# SECOND & WALL

210 WALL STREET

DOWNTOWN DESIGN REVIEW BOARD  
RECOMMENDATION MEETING  
SEPTEMBER 20, 2016  
DPD #3020932

SOUTH ELEVATION - WALL STREET

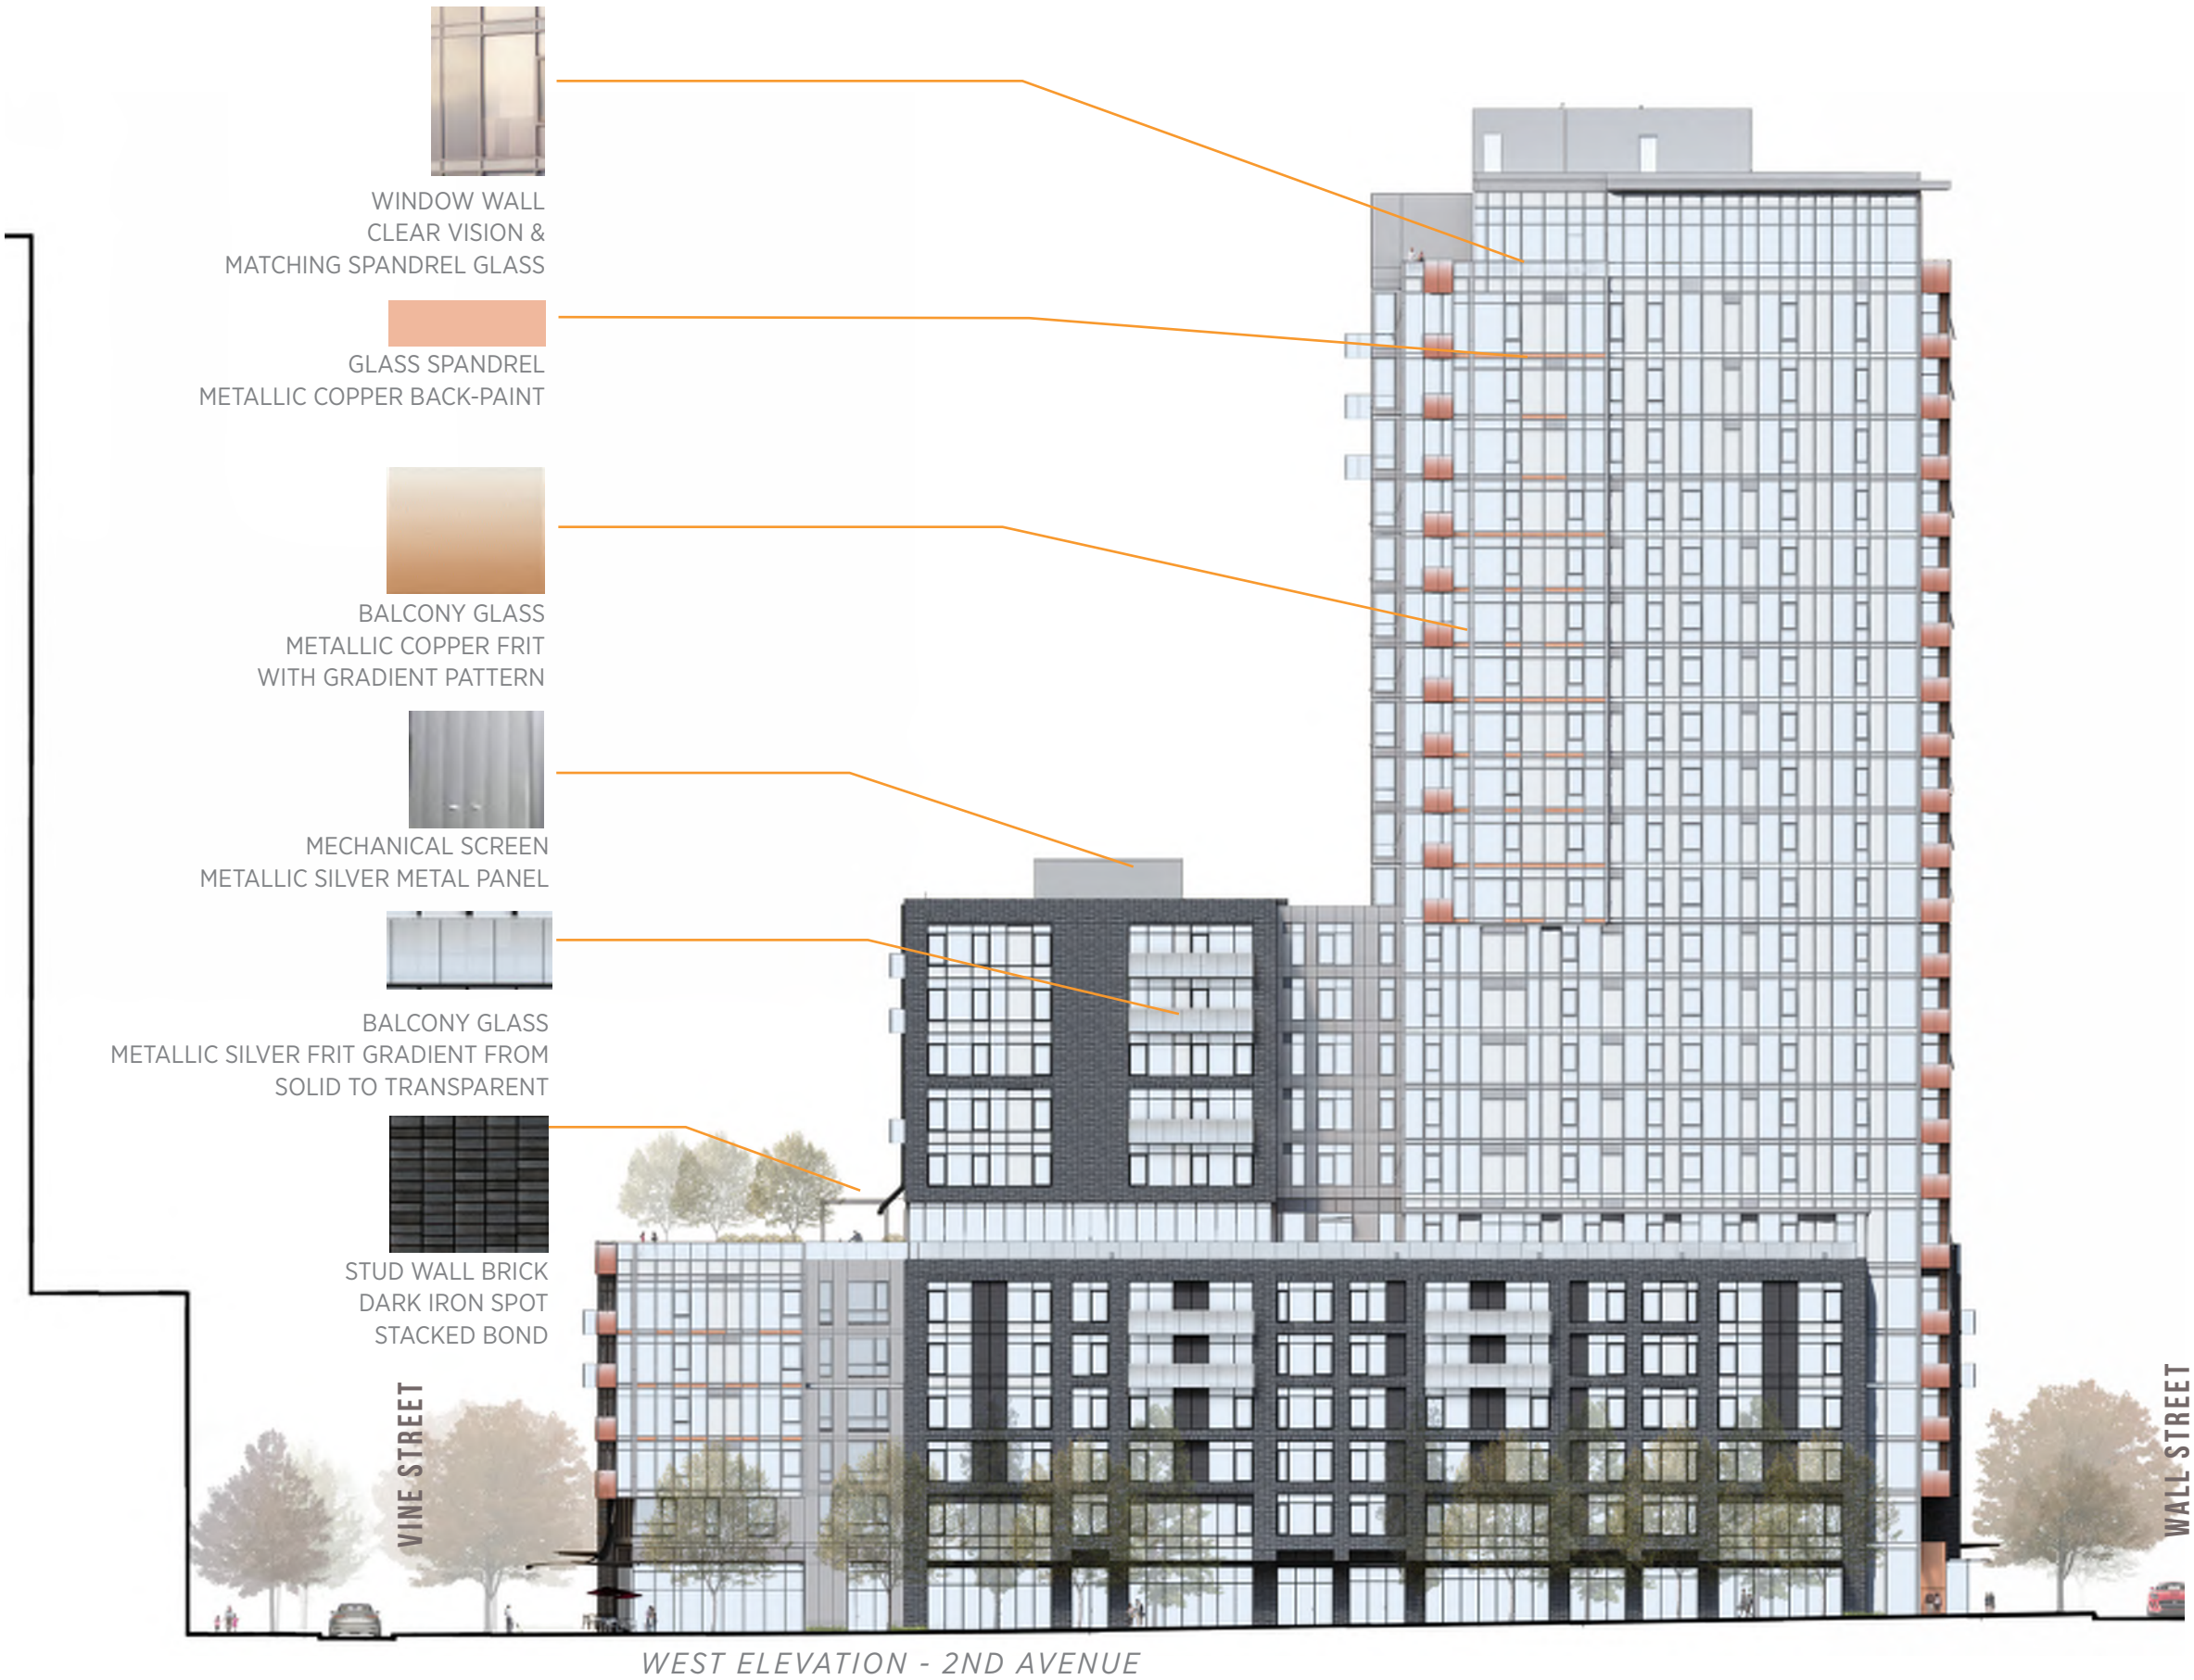
1.1.b).The Board recommended more complete elevations and perspectives of all tower sides.

Complete elevations and perspectives of all tower sides are provided in this packet.

LEVEL 13 STAIR  
EDG 2 DESIGN

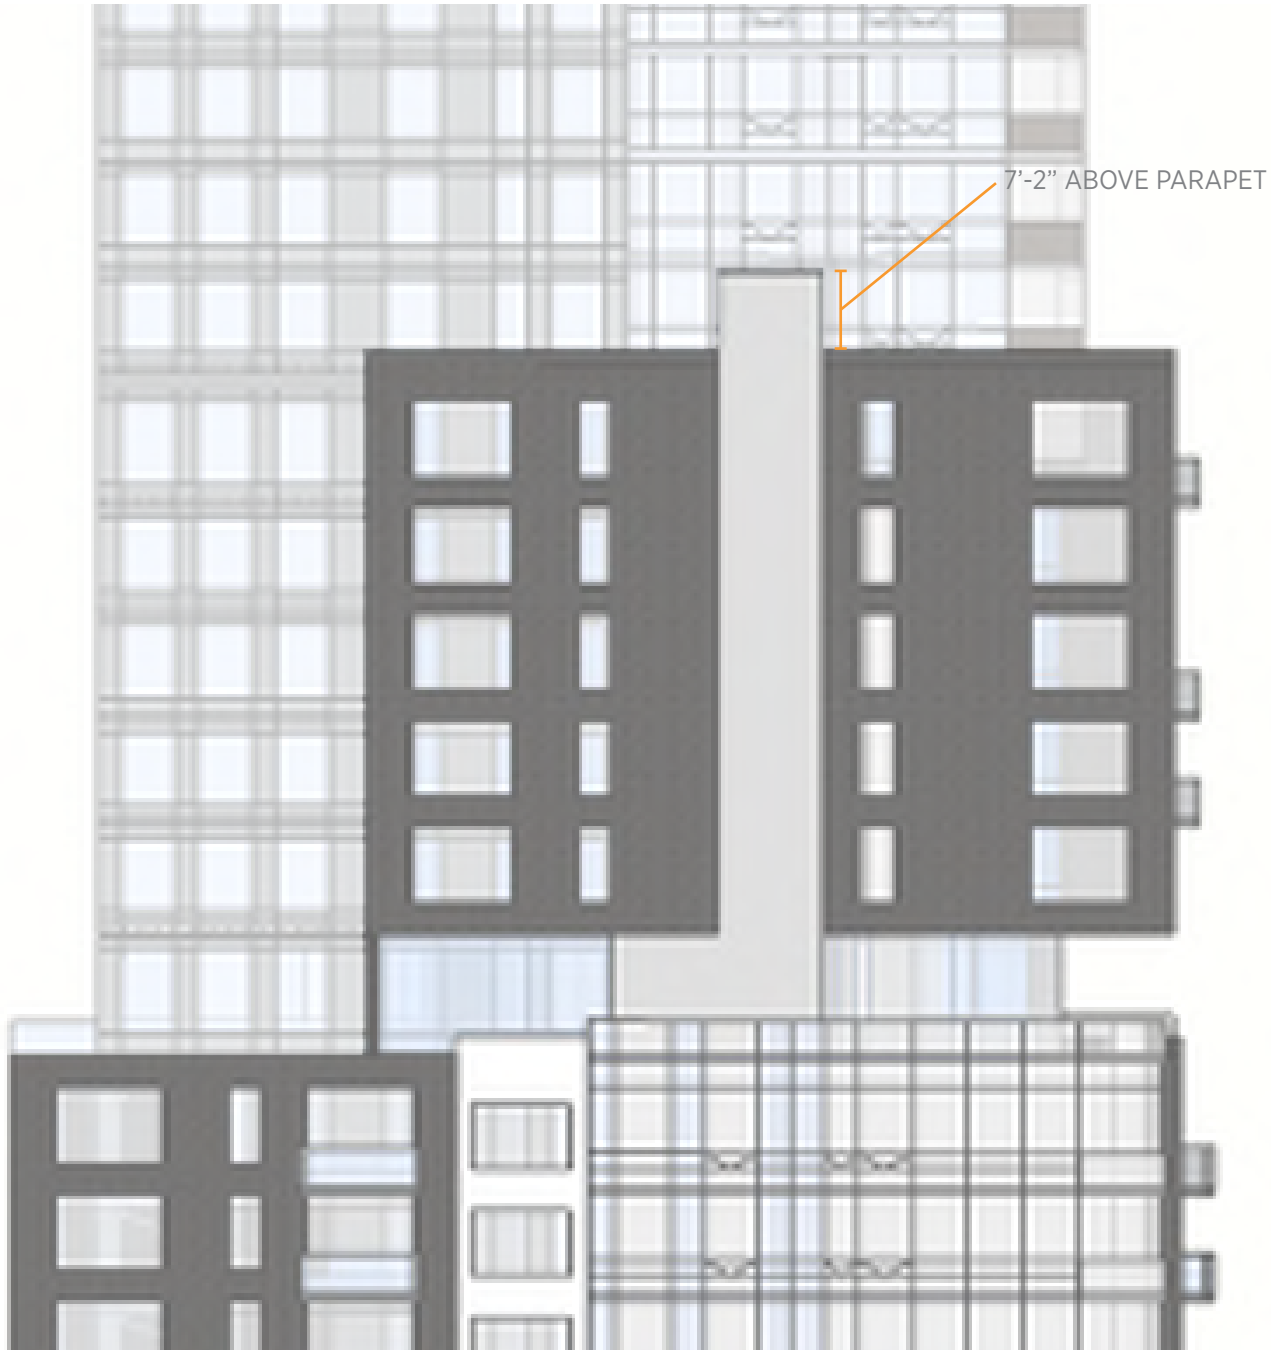
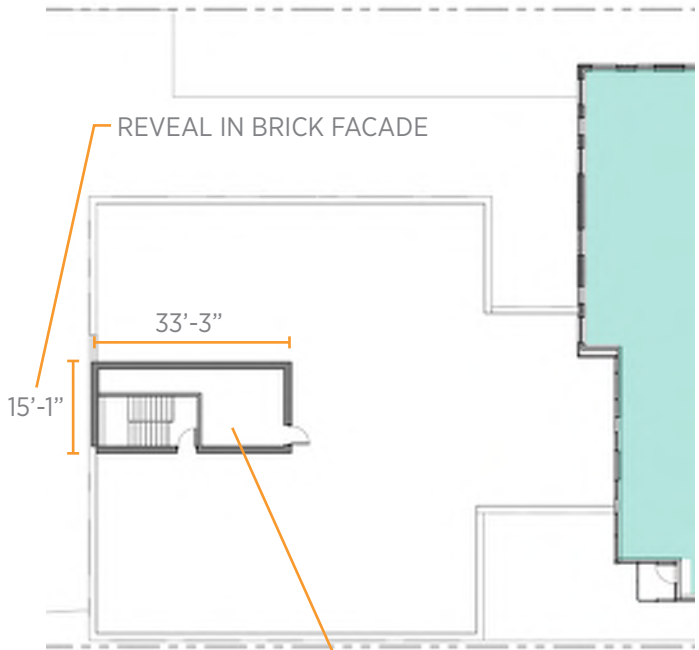
- 4 2.b).The level 13 green roof top requires further study of the stair overrun to better integrate it into the north wall of the mid-level 'cube'.
- 5 2.b).Reduce the level 13 stair overrun height.

LEVEL 7 - PROPOSED PODIUM ROOFTOP AMENITY PLAN

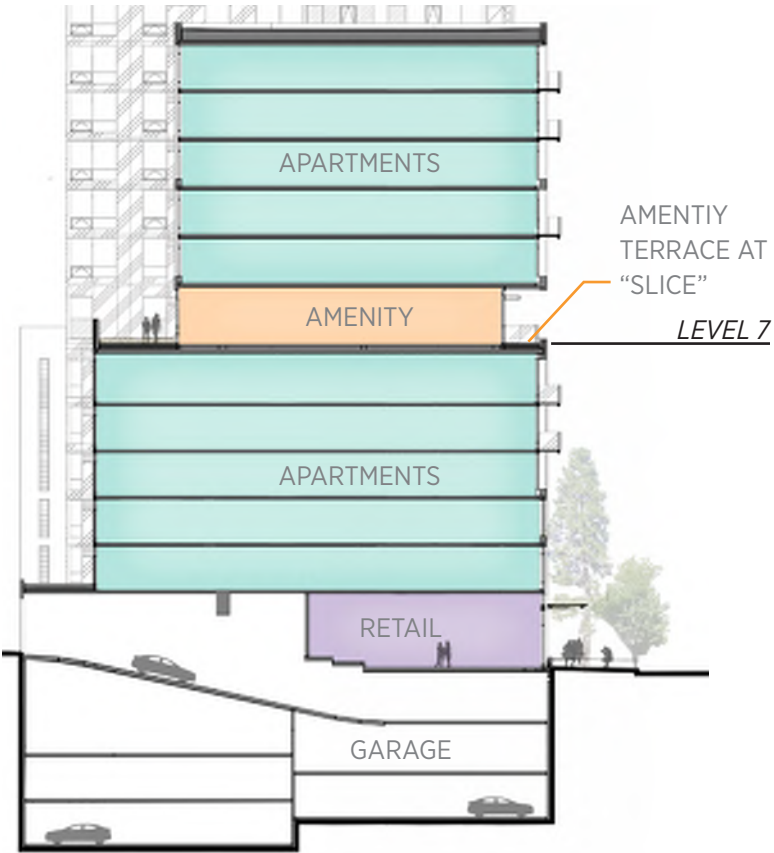
- 6 2.b.).Level 7 amenity deck should include canopy trees along the north and northeast alley to buffer neighbors and provide texture visible from the Green Street below.

Trees visible from the north and east have been added to the amenity deck.

RESIDENTIAL ENTRY  
REVISED DESIGN

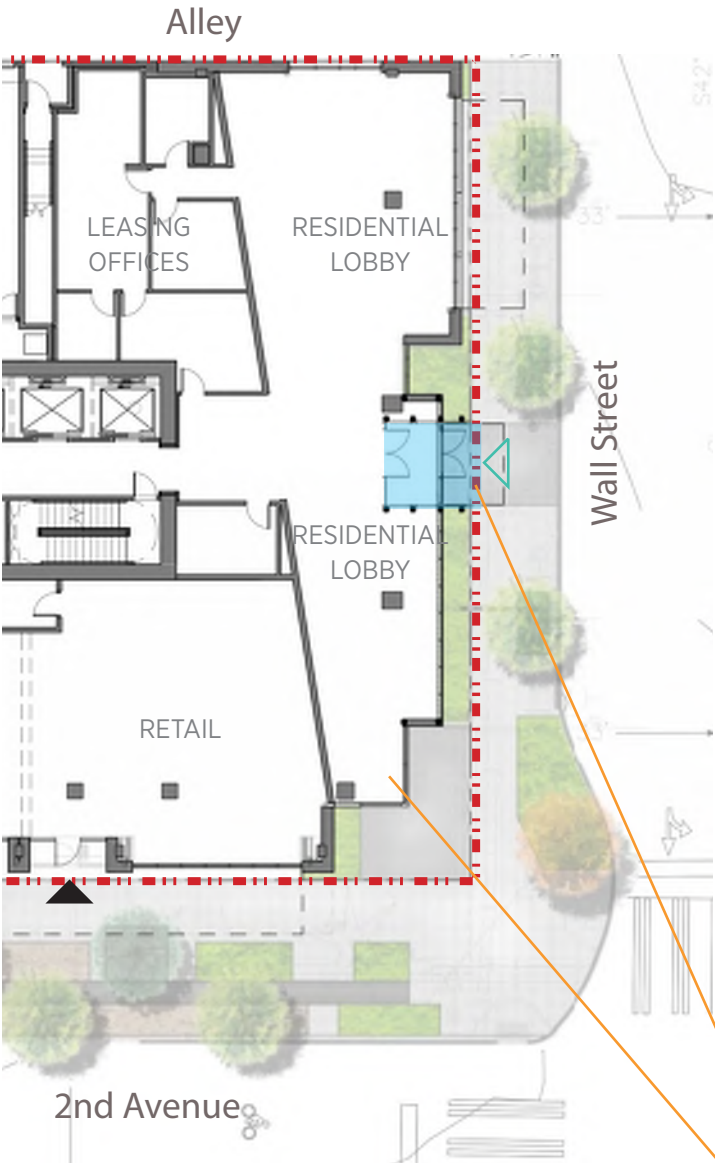
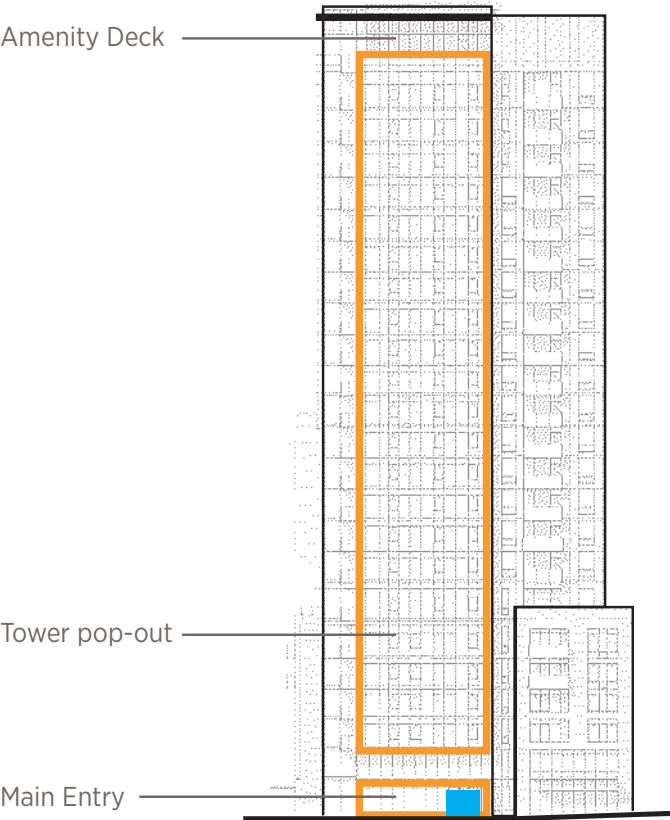
- 8 3.b).Residential lobby entrance should shift east and be composed as a legible, distinctive address under the tower form.
- 9 3.b).Ground floor retail should wrap the SW corner with doors accessing onto Wall Street.
- 10 3.d).The southwest corner should include a wrapping canopy.
- 11 3.a).The Board endorsed the deeply recessed storefronts, and supported a consistent rhythm of pier widths rather than the two widened piers along 2nd Avenue.
- 12 1.b).The Board supported the southeast corner element, and recommended studying the materiality of the northeast corner which has a similar condition.

- 8 The main entry doors have been shifted to the east. The entry massing aligns with the tower pop-out above, and has a vestibule made of a distinct materiality that draws pedestrians to the doors.

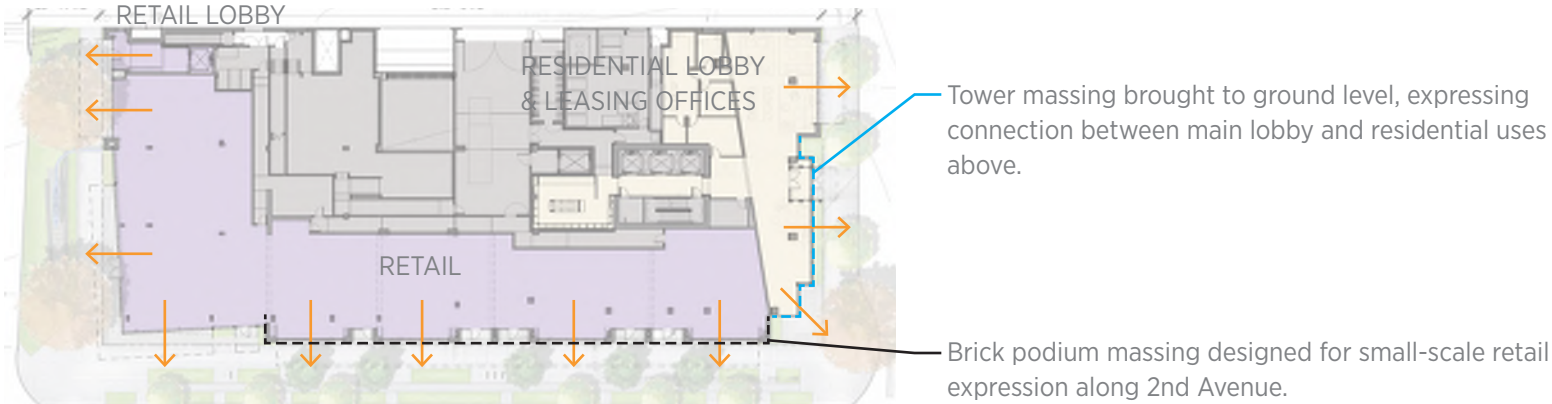
9 3.b).Ground floor retail should wrap the SW corner with doors accessing onto Wall Street.

The Zoning Code determines use requirements, and does not require retail use at this corner. Without a retail tenant contracted for the space, the design team is meeting the design guidelines by activating this corner with a unique art installation and feature wall in the lobby. However, the storefront is designed to accommodate doors and the space is easily converted to retail. The developer is committed to a rich, active, urban environment.
